Base Load Power Hub (BLPH)

60% 3D Model Review Report

Document Number: 123A90-DDL-PP-RE-70009

BLPH - 60% 3D MODEL REVIEW
ACTION ITEM REGISTER

MR30-TAG12

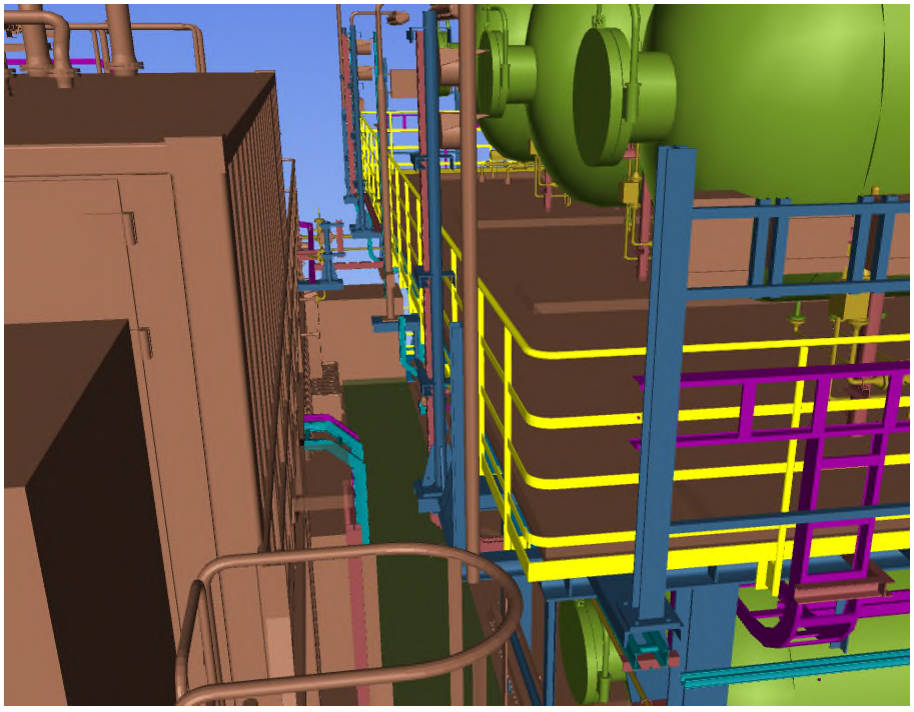
Distance between service platform and Elogen package to be confirmed.

The distance between the Electrolyser package and walkway platform has been increased

MR30-TAG13

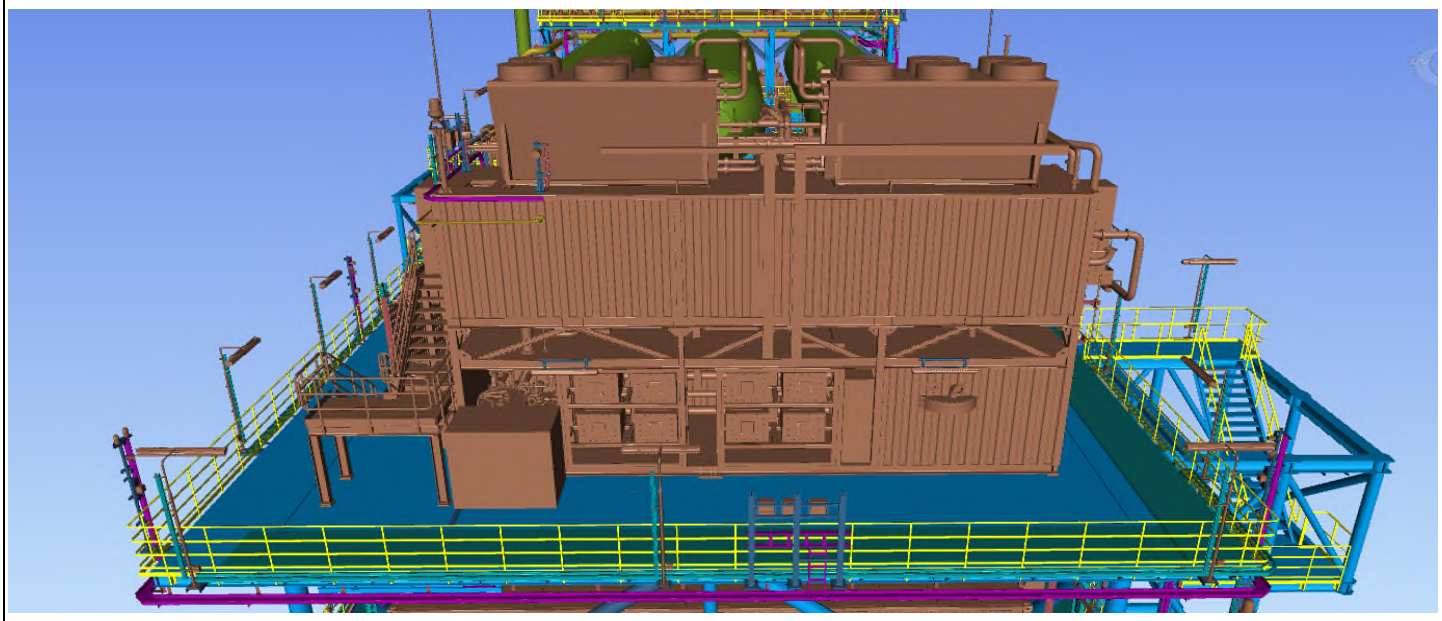
3D dimension of Electrolyser package to be confirmed by CPY.

Electrolyser package dimensions confirmed

MR30-TAG16

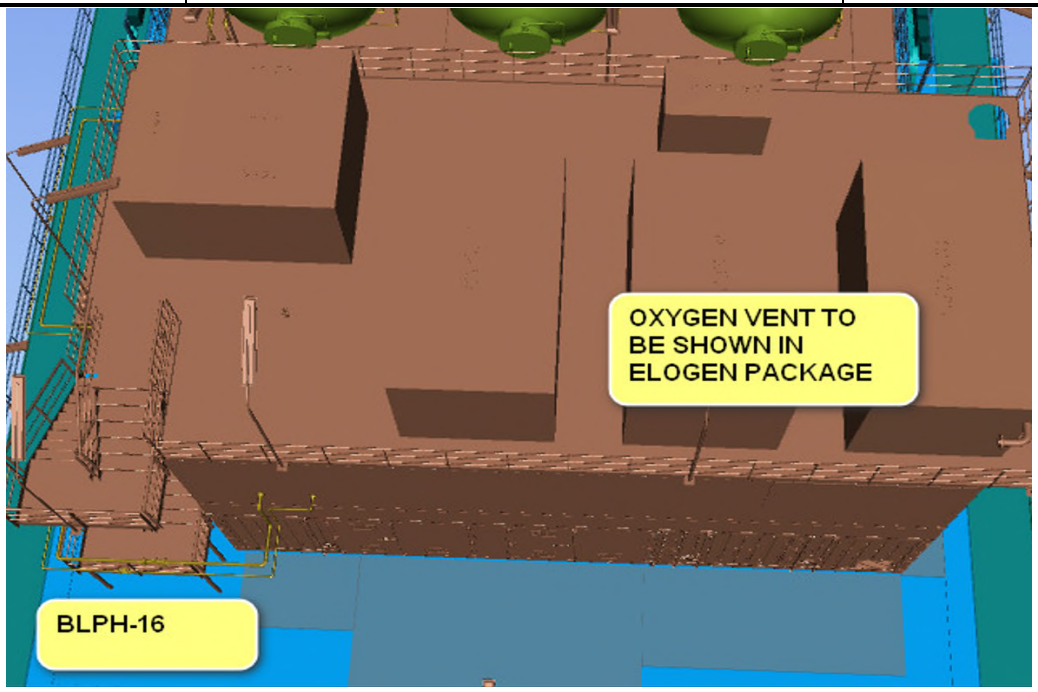
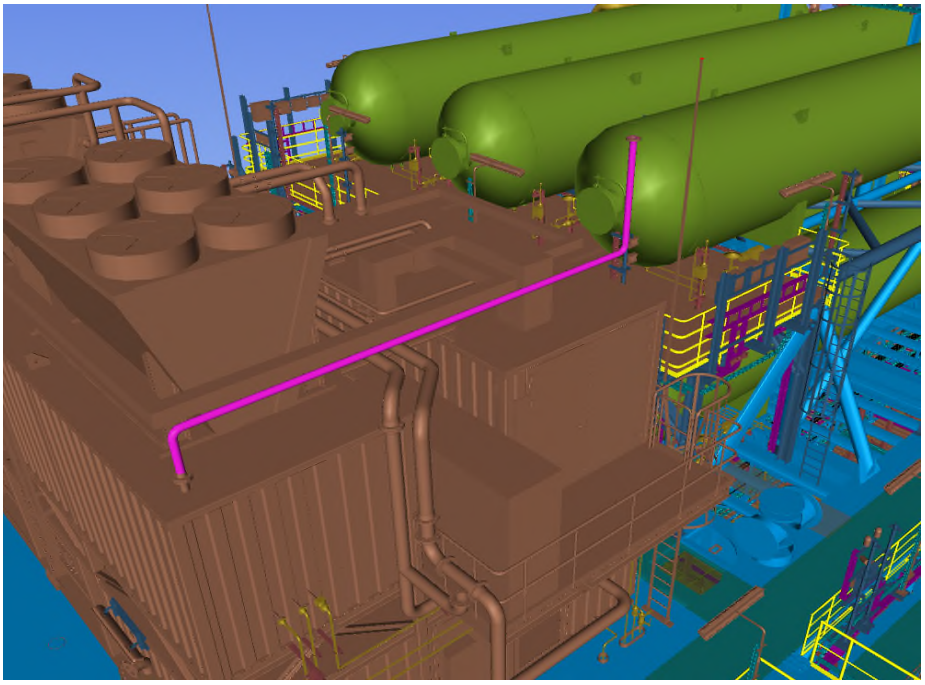
Oxygen vent to be shown in Elogen 3D package.

Oxygen vent shown

MR30-TAG18

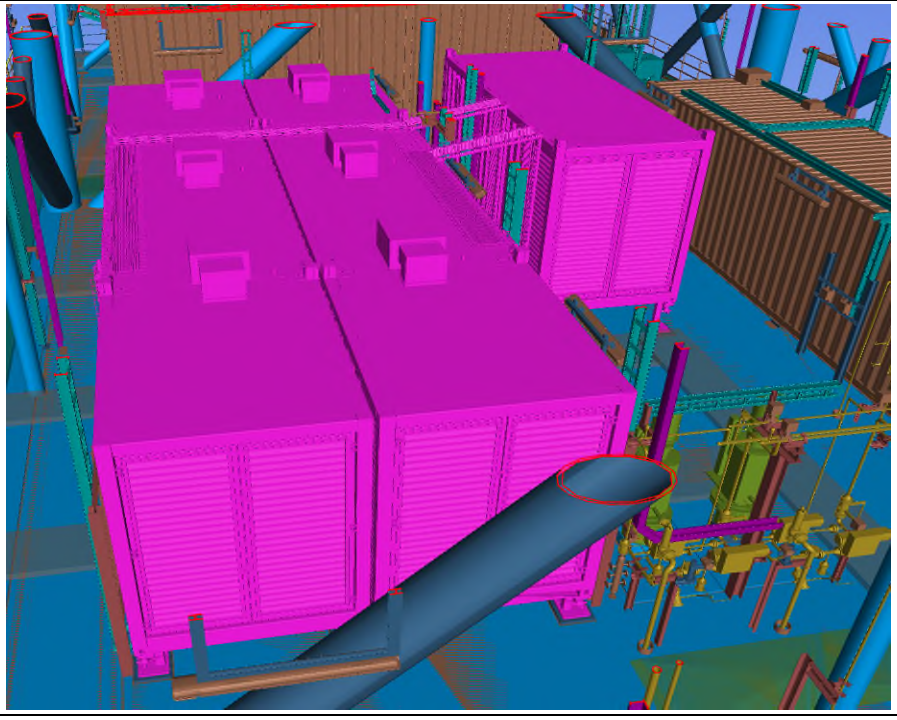
Bess containers to be updated.

Bess containers updated

MR30-TAG19

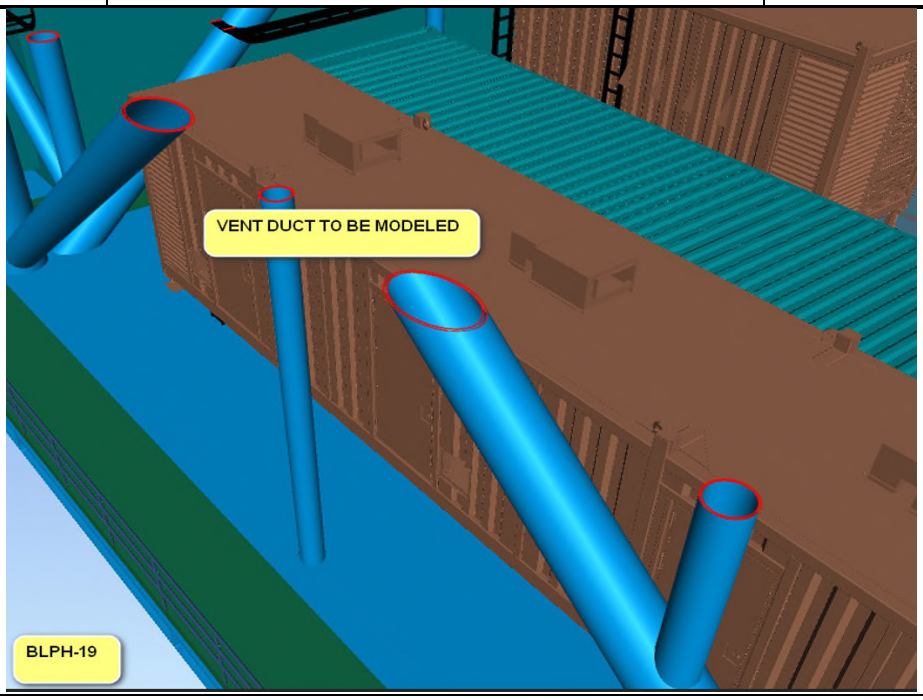
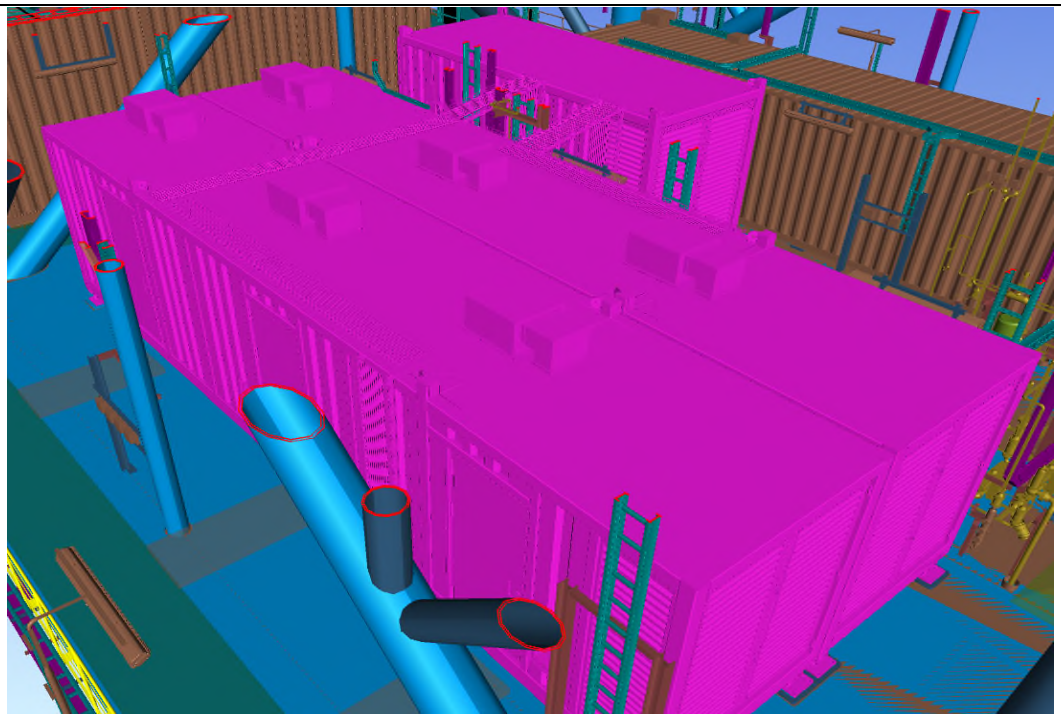
Vent duct to be modelled.

Vent duct are not provided since F&G detectors above the containers have been added

MR30-TAG21

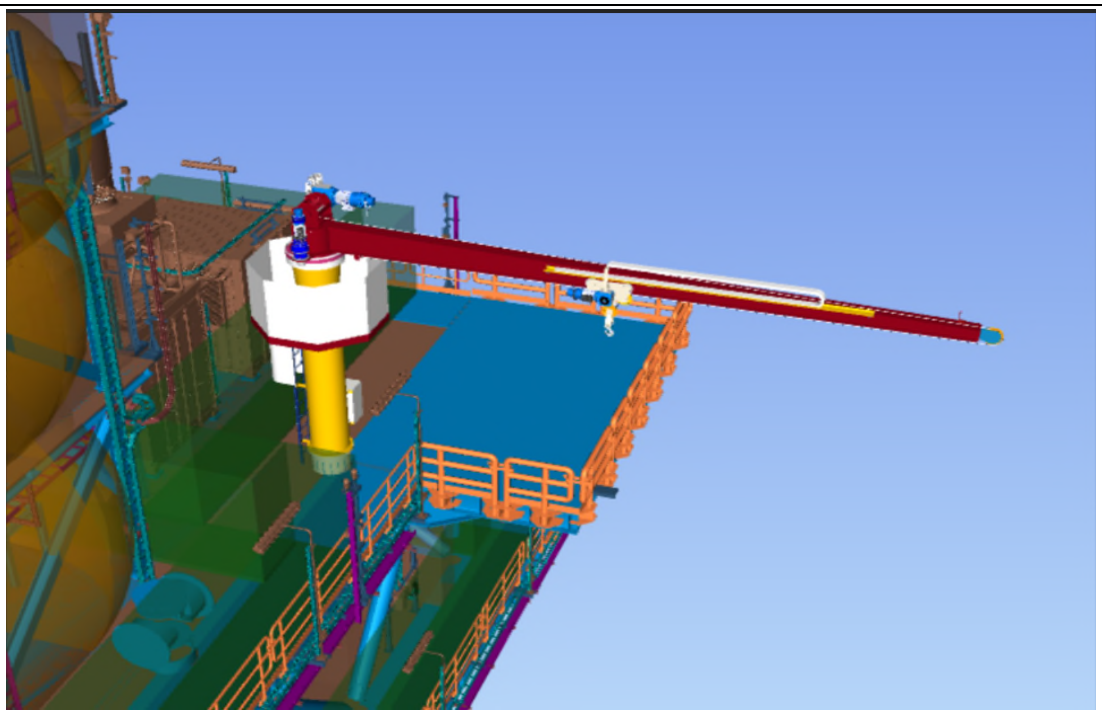
Crane and lifting details to be finalyzed.

Crane has been provided

MR30-TAG25

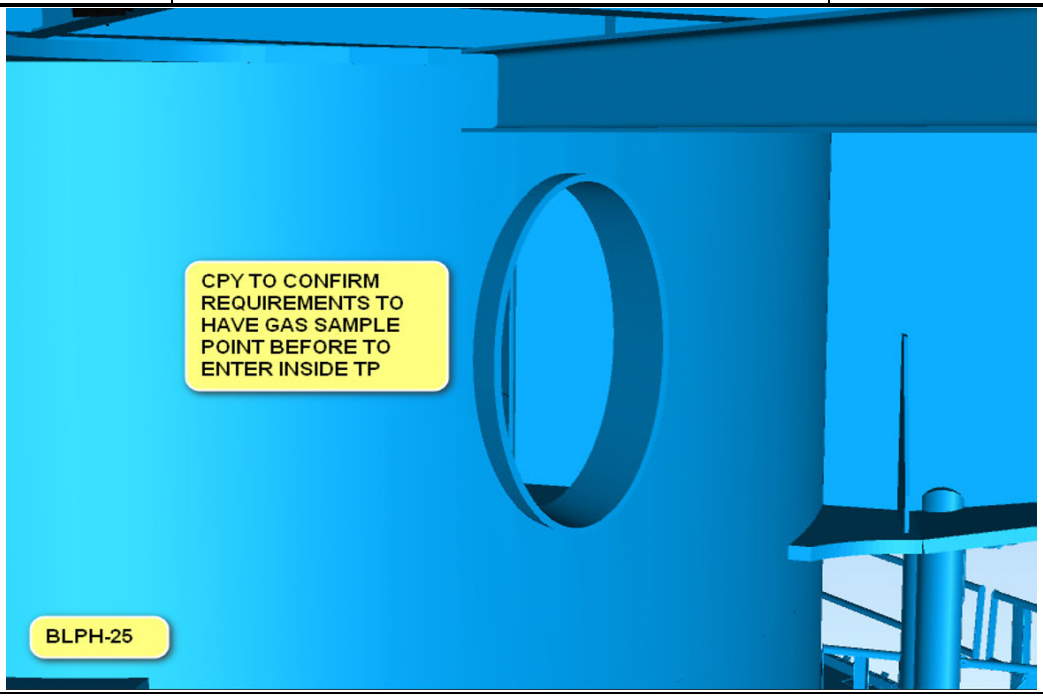
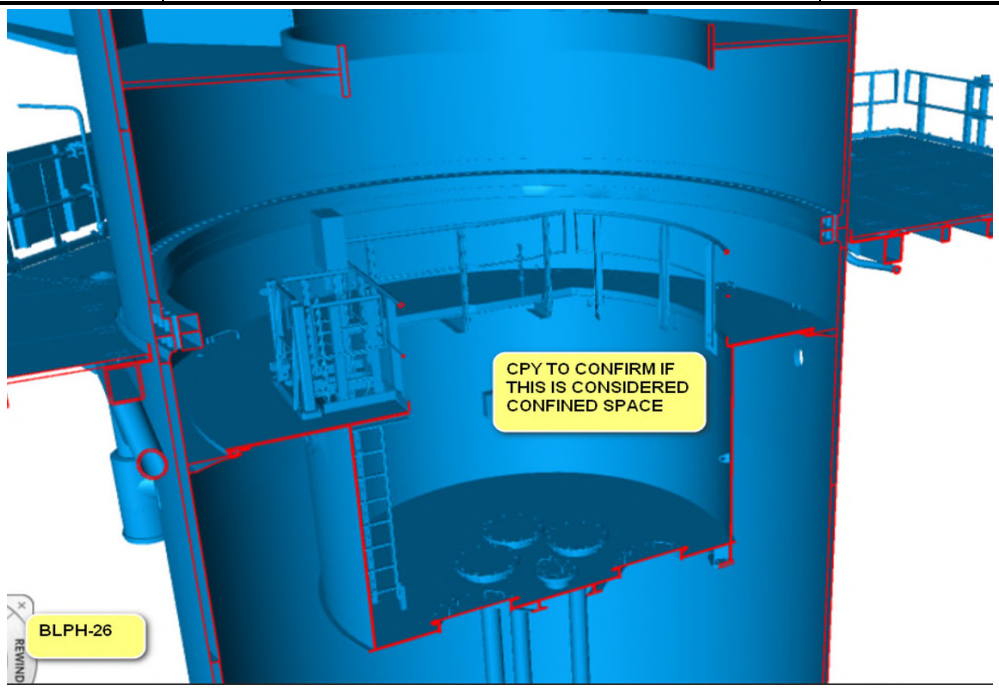
CPY to confirm requirements to have gas sample point before to enter inside TP.

Action postponed to 90%MR
